To: Bill Huffman - NRC
Subject: NRC/W NOTRUMP Meeting
Date: March 5, 1997
Pages: 13, including this cover sheet.

Attached is a partially complete table on the "road-map" to close OIS/RAIs/etc. for NOTRUMP V&V related issues. Please give Ralph Landry a copy so he can have a chance to review before we meet. We'll discuss this as part of Thursday meeting. Thanks.

SDSER Confirmatory Item #	Description of Item	Reference Where Answered
DSER-CN 21.6.2.4-1	The application of SIMARC drift-flux is acceptable pending confirmation of the model through benchmark and assessment of code to be provided in NOTRUMP Final Validation Report (FVR).	The NOTRUMP FVR (WCAP-14807, Revision 1) has been submitted.
DSER-CN 21.6.2.4-2	The modifications made to the NOTRUMP drift-flux correlations are acceptable pending confirmation of the model through benchmark and assessment of code to be provided in NOTRUMP FVR.	The NOTRUMP FVR (WCAP-14807, Revision 1) has been submitted.
DSER-CN 21.6.2.4-3	Westinghouse needs to verify that the NOTRUMP code does not use the Bjornard and Griffith modification.	
DSER-CN 21.6.2.4-4	Westinghouse needs to verify that heat link methodology for transition boiling is not used in A

471.23-3
Rev. 1

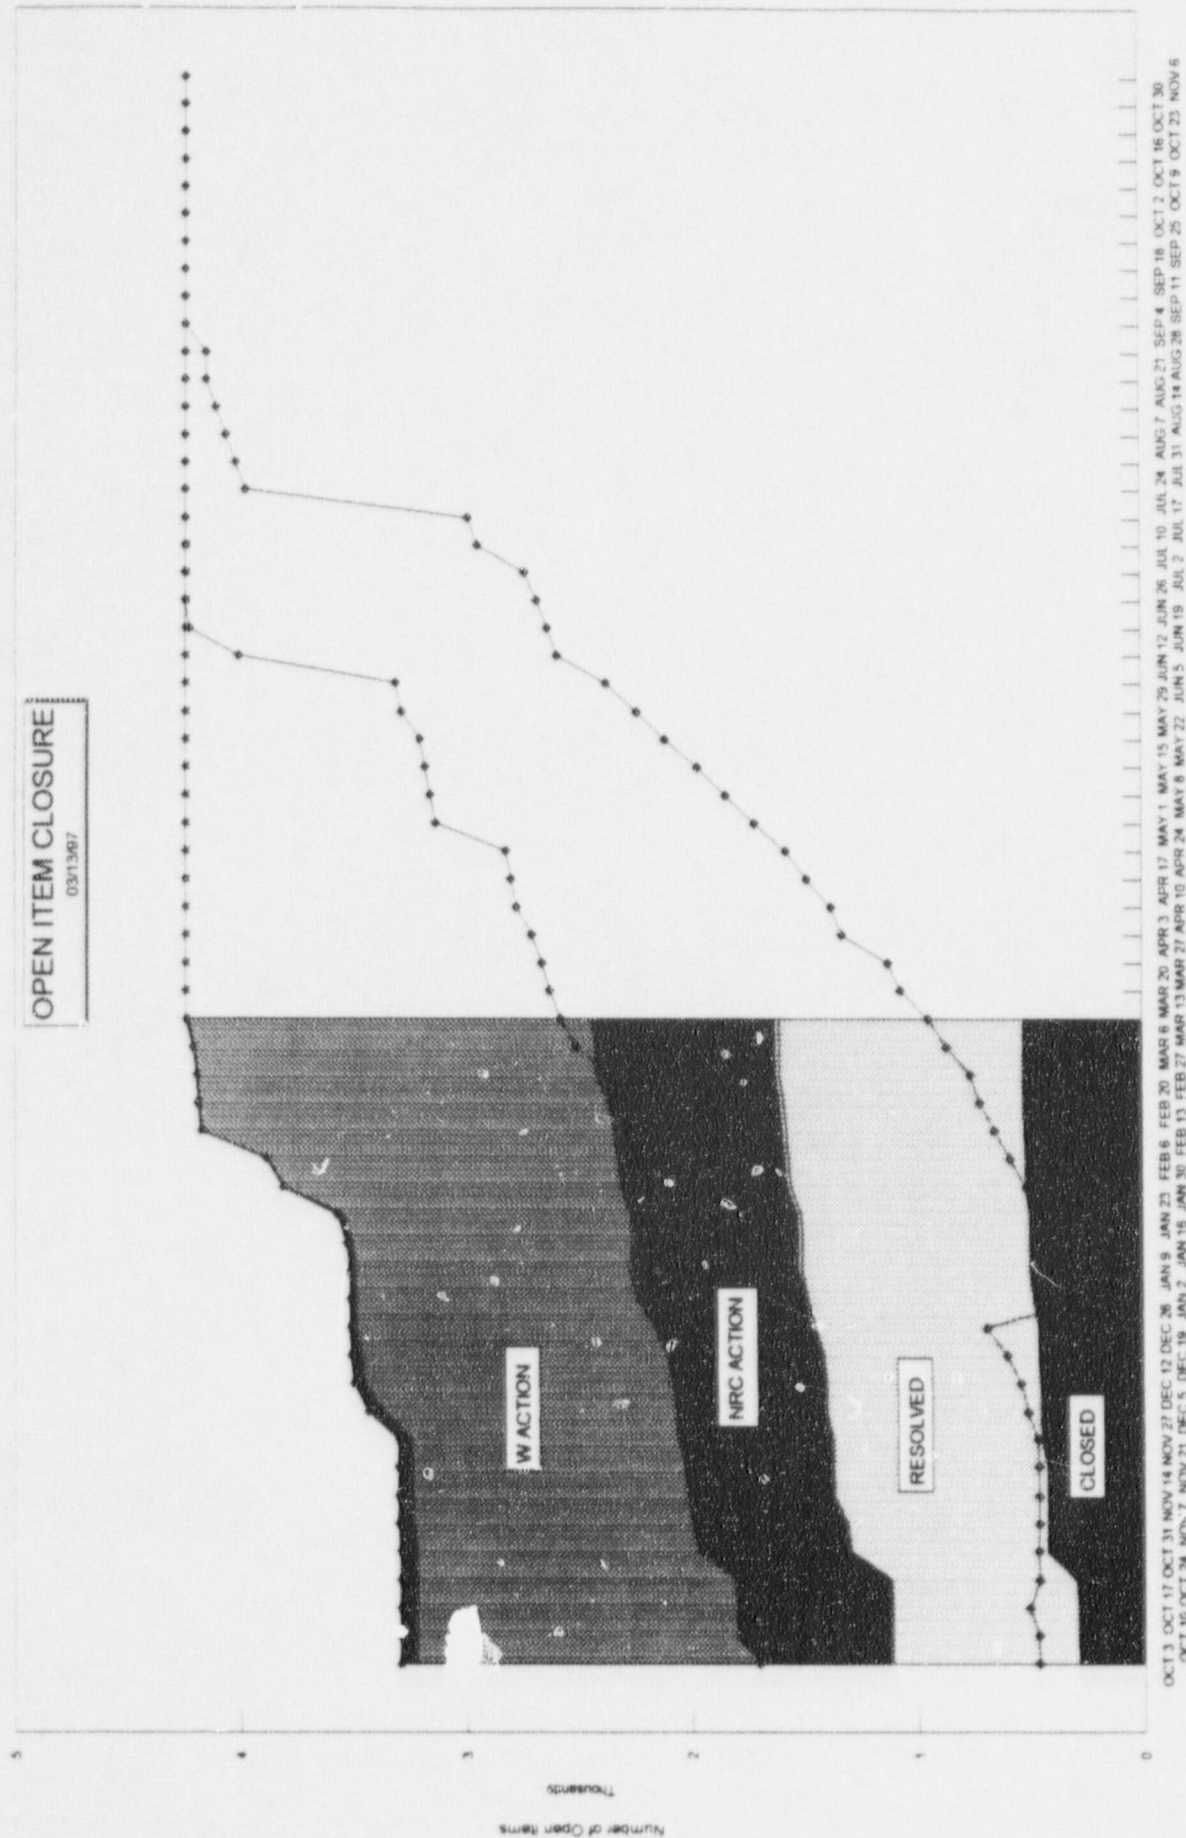
Verify that the airborne radiation monitors described in Section 11.5.2.3.2 of Chapter 11 of the SSAR will be sensitive enough to detect 10 DAC-hrs in any area of the plant that can be accessed by plant personnel.

- In "Notes:" add:

"5. Monitor is sensitive enough to detect 10 Derived Air Concentration (DAC)-hours."
